SUNDRY NOTICES AND REPORTS ON WELLS

8. Well Name and No.
CALLOW 5

Plug and Abandonment Procedure

Re: Permanent Abandonment
Well: G H Callow 5

Proposed Wellbore Diagram

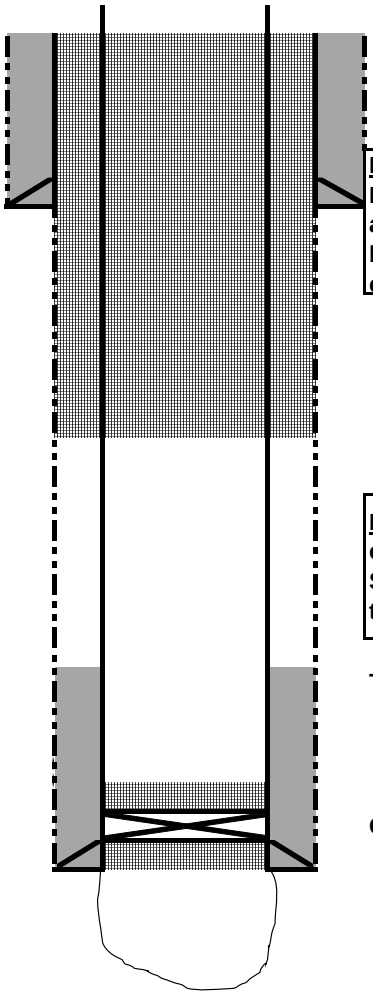
Remarks:
P & A
- Please ensure that the top of the Fruitland, as well as the entire Ojo Alamo aquifer, identified in this report, are isolated by proper placement of cement plugs. This will protect the freshwater sands in this well bore.
